PLANNING REPORT

Planning and Zoning Commission

Dublin Senior Living 26-041CP

Case Summary

Proposed Concept Plan

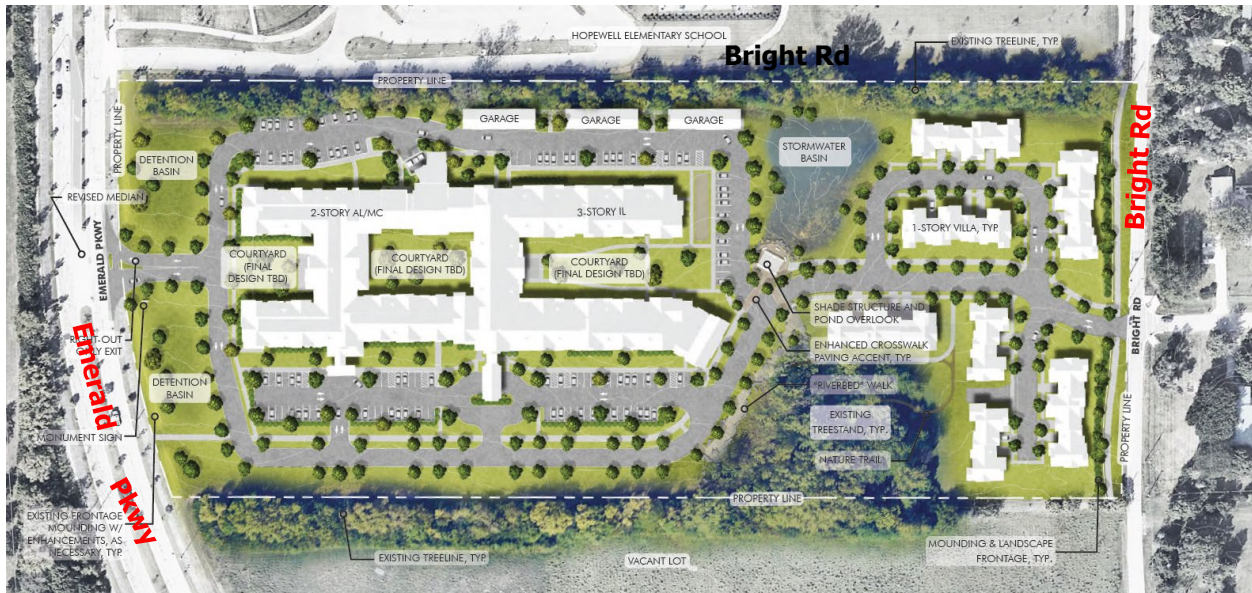
This request shows a 2-3 story independent living, assisted living, and memory care building with a total of 175 apartments plus 19 villas. The main building is perpendicular to Emerald Parkway in the south portion of the site, with primary access onto Emerald Parkway. Parking is on three sides of the building, with the Emerald Parkway frontage being reserved for access. Covered, separate parking garages are shown to the northwest of this building. The trash enclosure is now integrated into the main building.

Property line tree rows are shown to largely be maintained, as is the bulk of the tree stand south of the former house site. The center tree row is removed, as is the majority of trees on the west half of the stream. See additional comments below.

1) Has the proposal's density adequately responded to *Envision Dublin*/SAP and the site context?

At INF, the Commission offered general support for the use, but had concerns about building massing, which directly translates to density. The target density for this location is not to exceed 9,500 SF/acre. The NO portion of the site has approximately 11.53 acres of land, which could therefore accommodate up to 109,535 SF per *Envision Dublin*; shown is 207,514 or 17,998 SF/ac. For comparison, The Beacon was approved with additional density due to lower traffic impacts based on the type of use.

Staff requests specific reaction to the proposed density.

Future Land Use

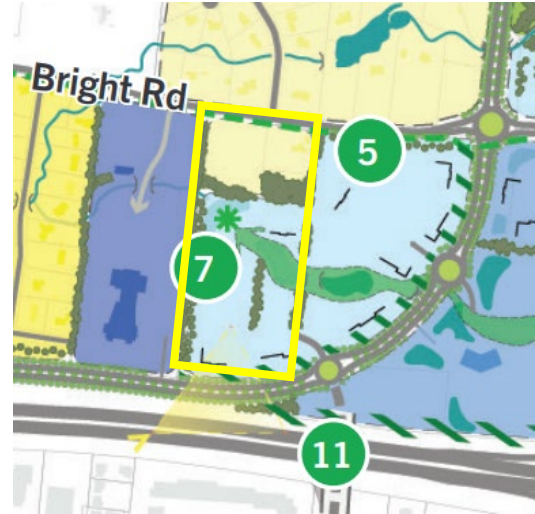
The *Envision Dublin* Future Land Use (FLU) Map indicates Neighborhood Office (NO) for this site, which includes office/medical office, and supporting uses of institutional, including assisted living. A note (pg 47, *Envision Dublin*) that applies to all land use categories states that while supporting uses are to be combined with principal uses, some uses that do not alter the intent of the district may be located without a listed principal/particular use. Density for NO is “generally not to exceed 9,500 SF per acre.”
